Sheet CG-101

DRAINAGE CERTIFICATION WITH VERIFICATION BY ENGINEER OF RECORD

CESAR CHAVEZ SPLASH PAD GRADING & DRAINAGE PLAN

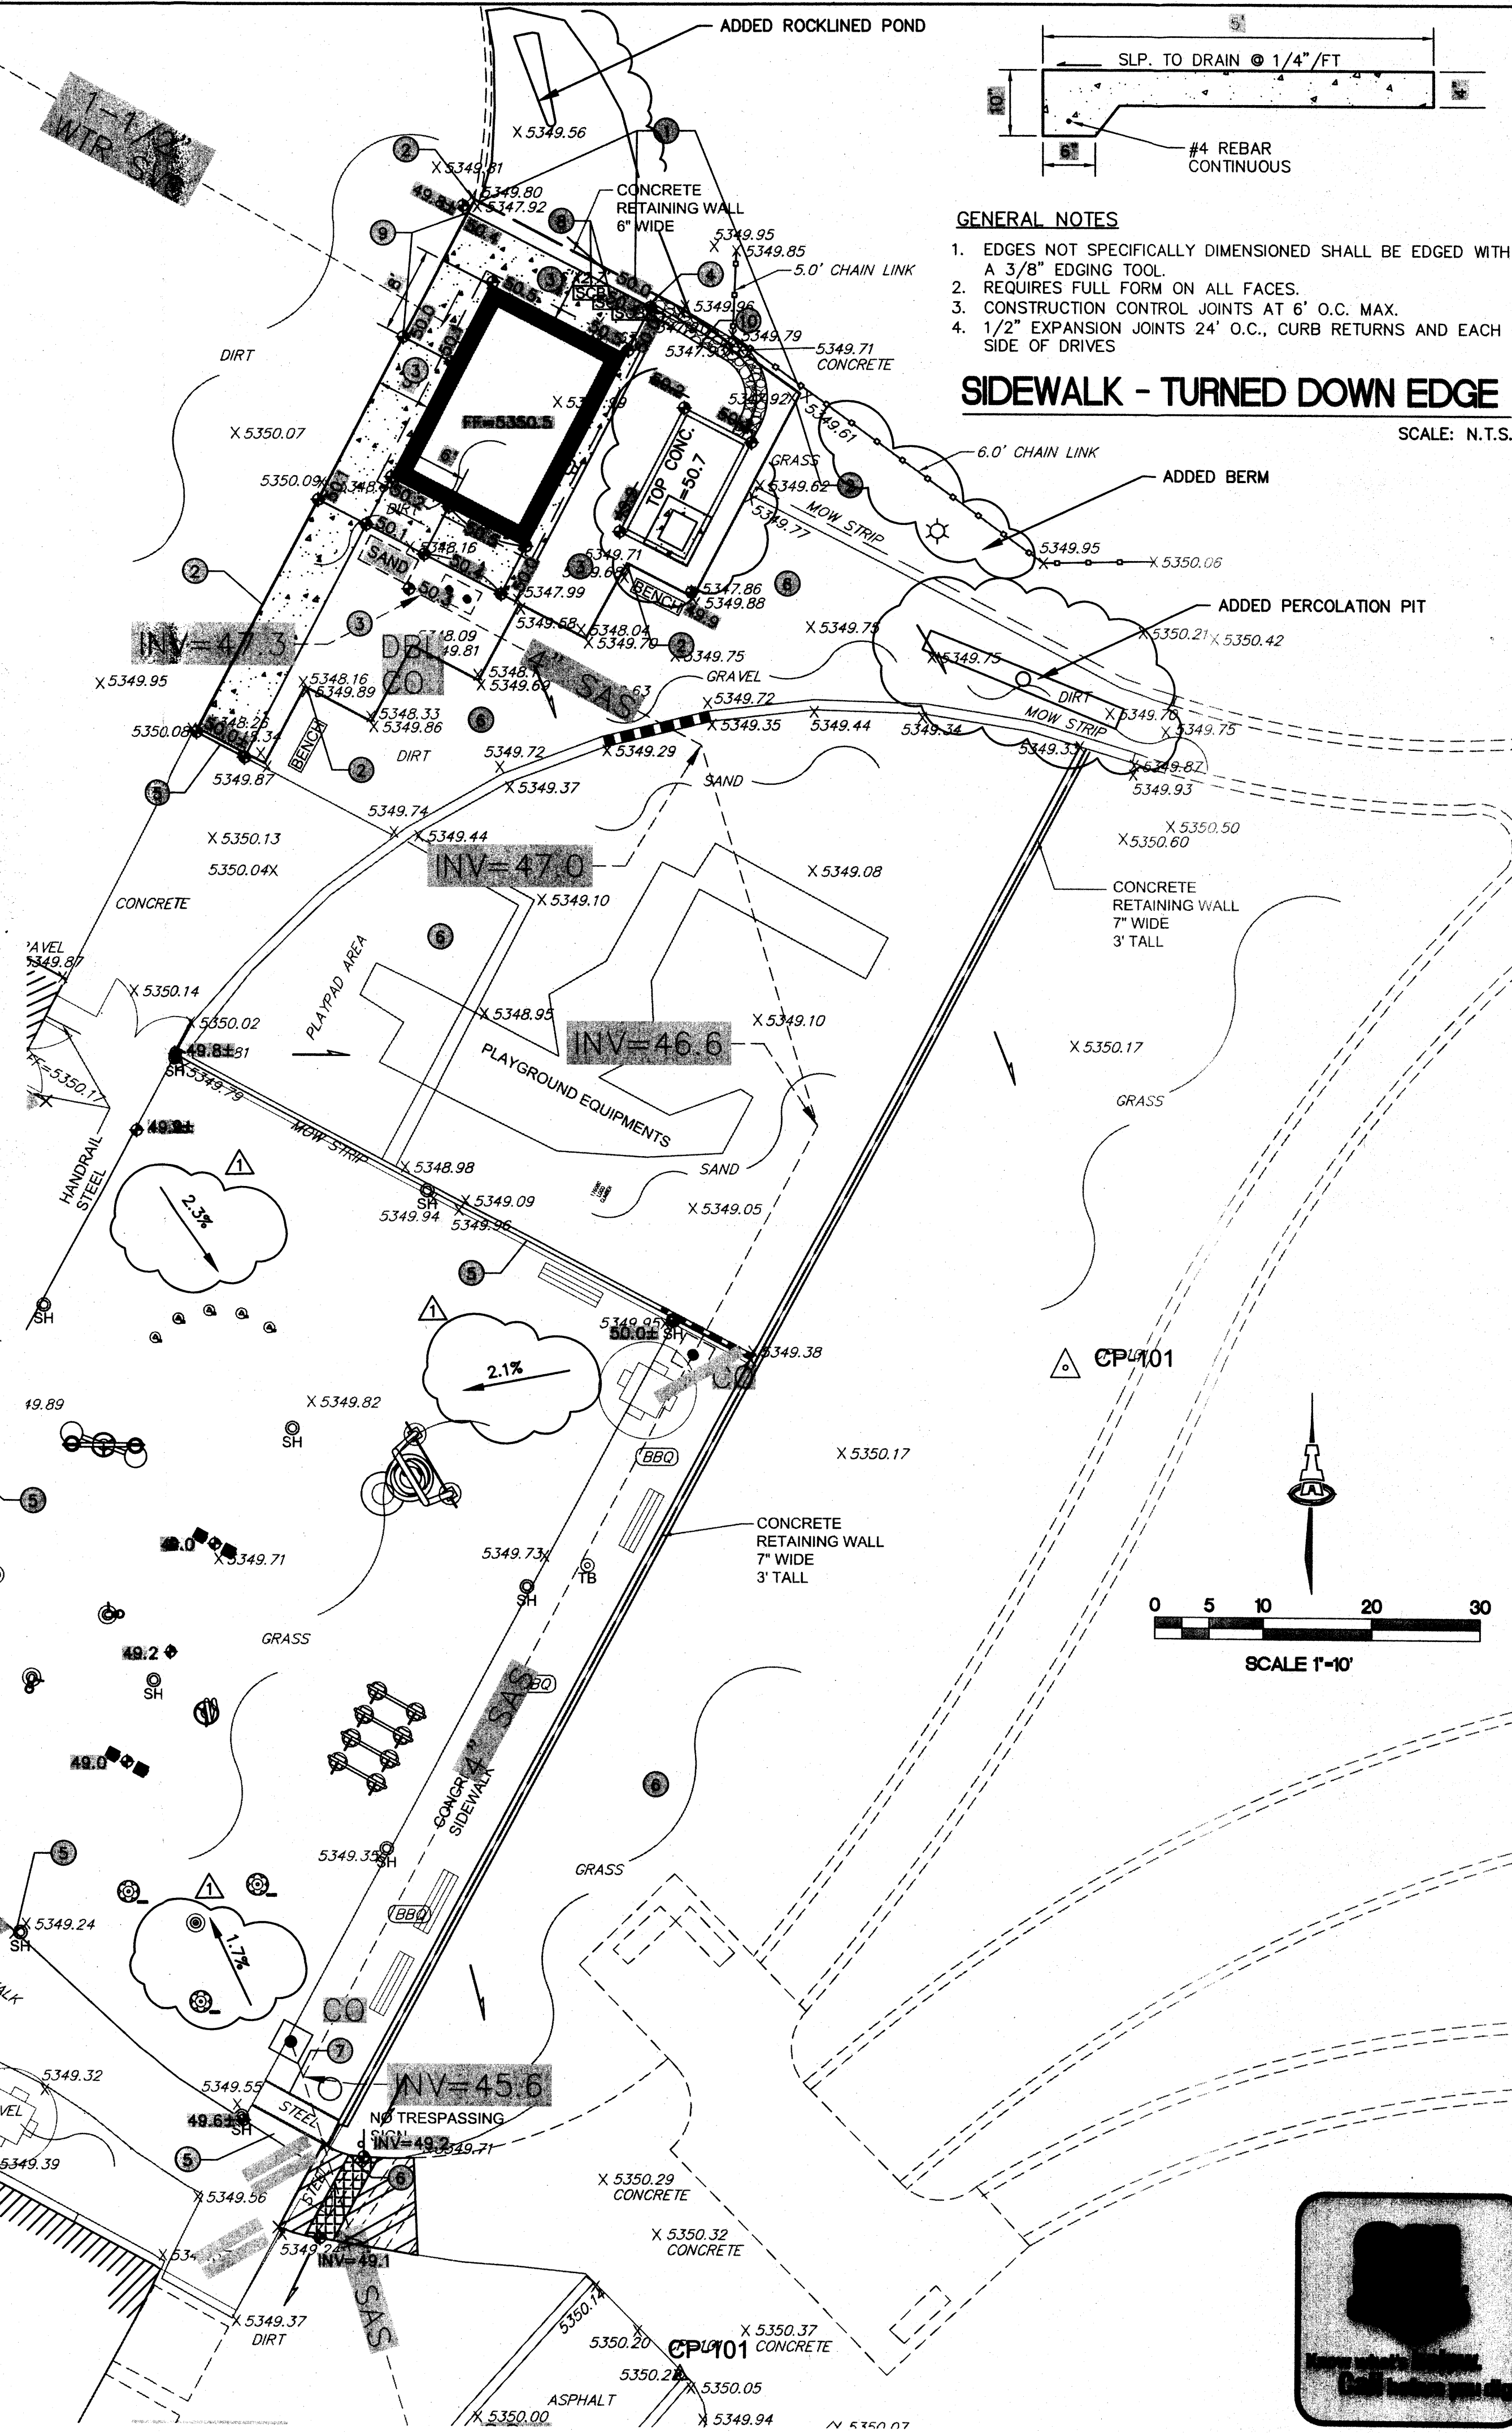
1. A retention pond was added north of the pump house to capture offsite flows from the adjoining ball field.
2. A percolation pit was added north of the playground equipment area to reduce surface ponding within the landscaping.
3. A berm was added along the north fence to redirect offsite flows from the adjoining park and ball field.
